**SECTION 01 30 01**  
**REQUEST FOR INTERPRETATION FORM**  
**CONSENTINO MIDDLE SCHOOL - #21-0818**

<b>TO:</b> Dore & Whittier Architects Inc. 260 Merrimac St., Bldg.7 Newburyport, MA 01950	<b>FROM:</b>  Brait Builders	<b>RFI #:</b>  RFI - 038
<b>Attn:</b> Tara King	<b>Reply Requested by:</b> Jake McDonough	<b>Issue Date:</b> 05/24/24
<b>RFI DESCRIPTION</b> (Indicate origin of RFI, and summarize the question or type of information required):  Please see attached drainage clocks with constructibility issues. Please advise how to proceed.		
<b>REFERENCES</b> (List relevant Drawings or Specification sections and paragraphs):  		
<b>SENDER'S RECOMMENDATION</b> (All RFIs must include a contractor's recommended solution to each condition, including a statement of cost or schedule of impact if applicable. The contractor may be back-charged by the Owner for designer's review time for any RFI submitted without a sender's recommended solution or where response is evident in Drawings.)  Nitsch Comment: Refer to comments below and ASI-11 for updates.

RFI No.: JDC-03

PROJECT: Haverhill MS  
ADDRESS: \_\_\_\_\_  
\_\_\_\_\_

Structure: CB 118  
Based On:  
Job Name: CONSENTINO MIDDLE SCHOOL  
Job Location:  
Specification: 48" Storm  
Contractor: DERENZO

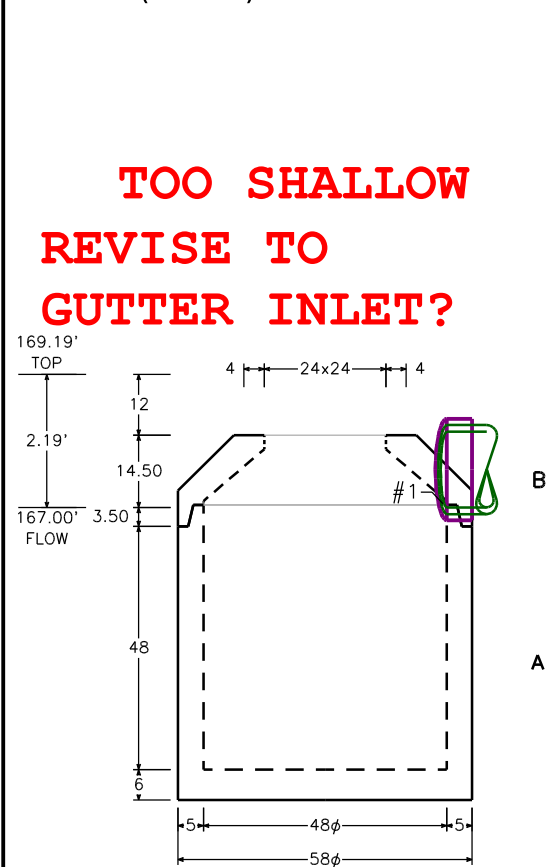
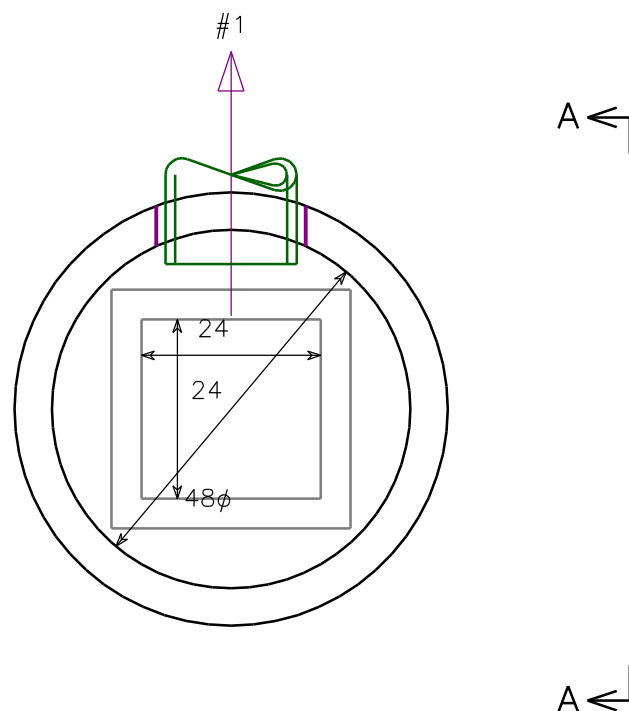
Please see attached drainage clocks with constructibility issues. Please advise how to proceed.

Nitsch Response:  
Outlet lowered to 166.52  
(assuming flat top structure)  
Refer to ASI-11 as this lowered  
some downstream inverts as well

Structure: D 202  
Based On:  
Job Name: CONSENTINO MIDDLE SCHOOL  
Job Location:  
Specification: 48" Storm  
Contractor: DERENZO

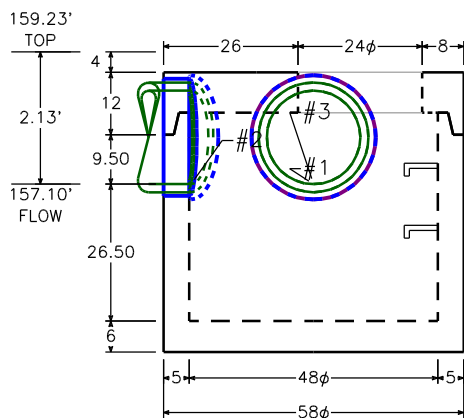
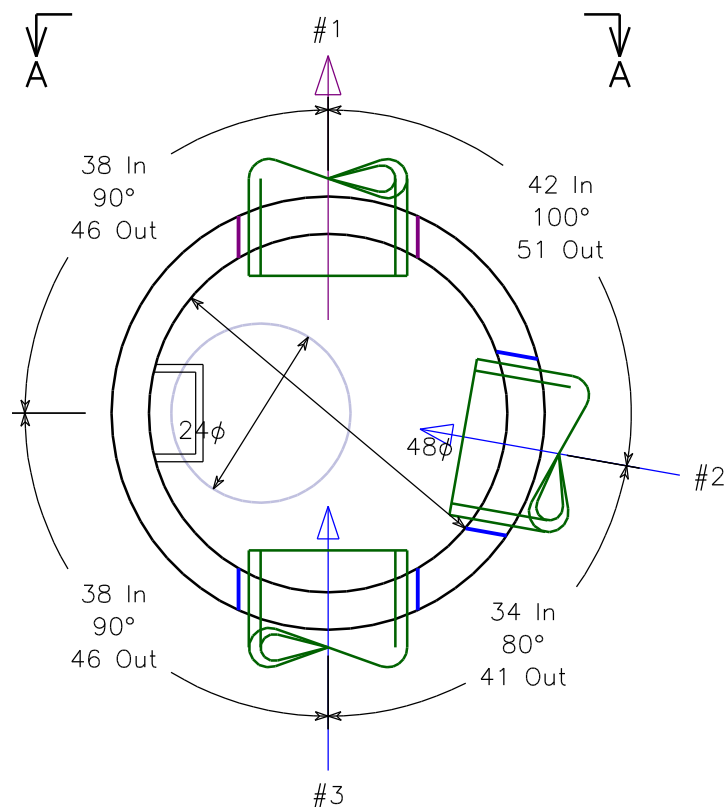
**TOO SHALLOW**  
**TEE**  
**CONNECTION TO**  
**MAIN?**

Nitsch Response: Revise  
rim to finish grade ~162.50  
(Refer to ASI-11)

Structure: D 226  
Based On:  
Job Name: CONSENTINO MIDDLE SCHOOL  
Job Location:  
Specification: 48" Storm  
Contractor: DERENZO

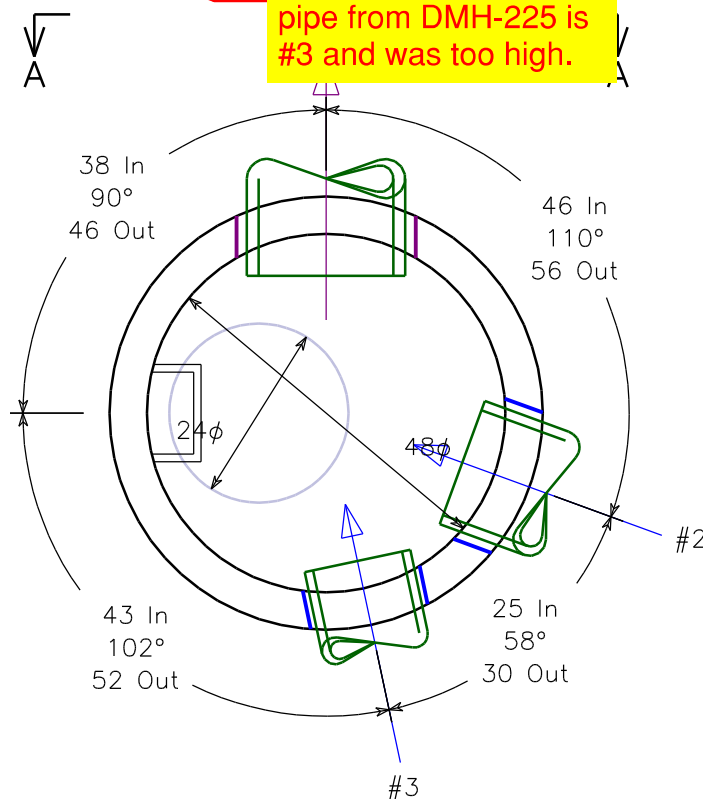
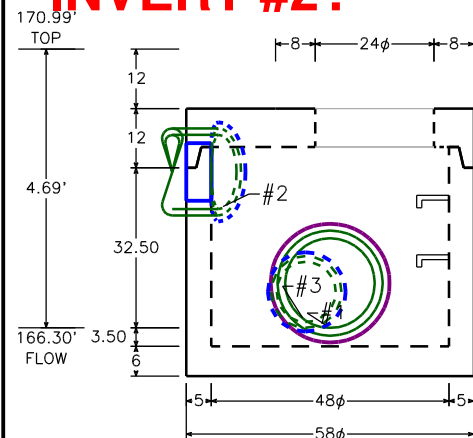
TOO SHALLOW  
LOWER  
INVERT #2?

Nitsch Response: Update  
Inverts per ASI-11

Structure: CB 118  
Based On:  
Job Name: CONSENTINO MIDDLE SCHOOL  
Job Location:  
Specification: 48" Storm  
Contractor: DERENZO

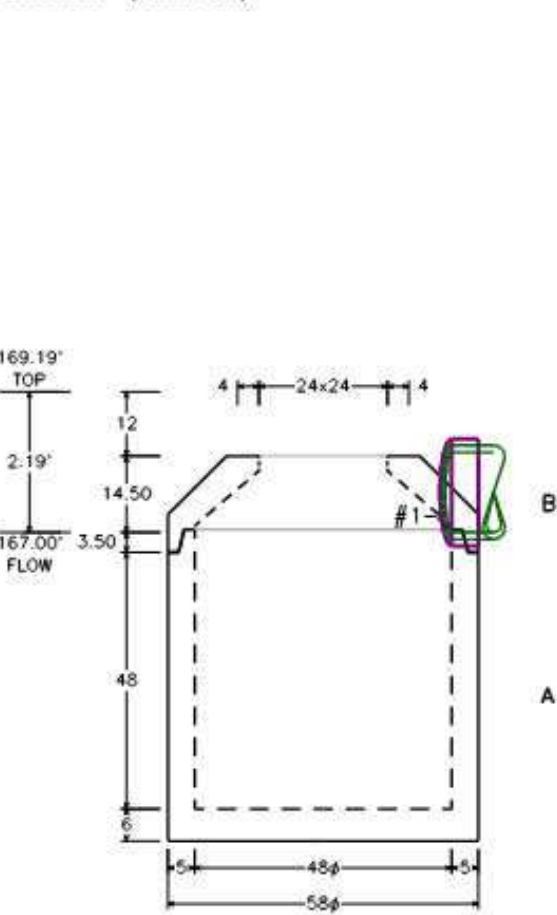
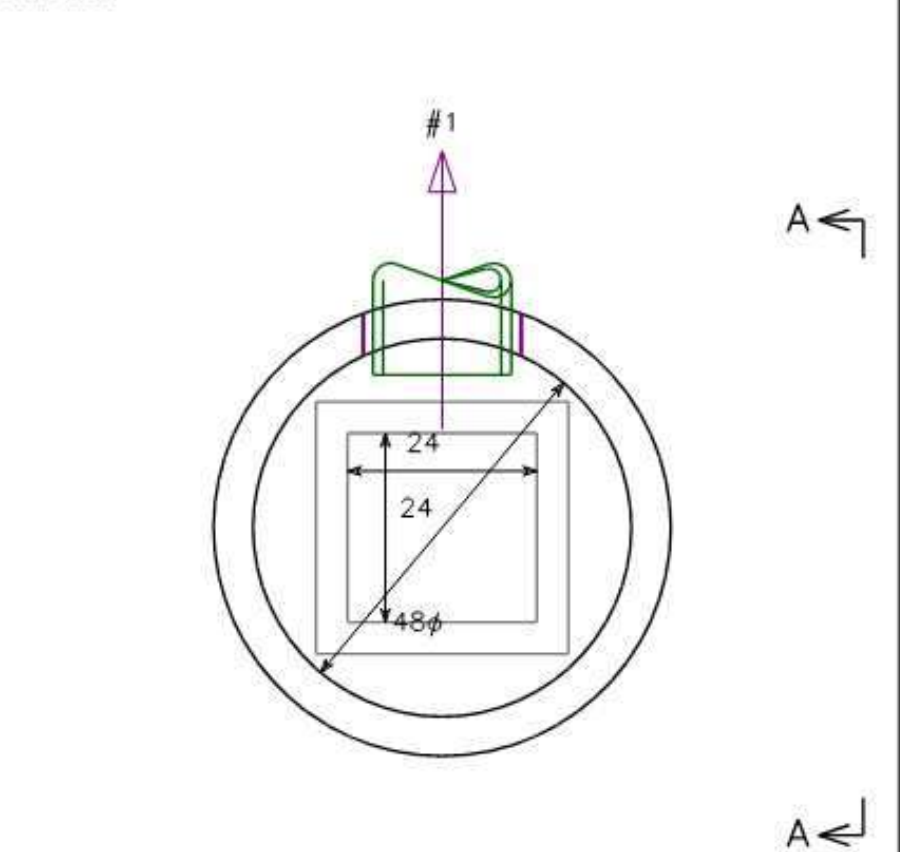
Pipe is 18" too shallow. Zero pitch to play with towards WQs-1 that it connects too. Please advise.

Nitsch Engineering - 2024-07-19 M. Valentino  
Please see the attached PR-04 which includes invert revisions.
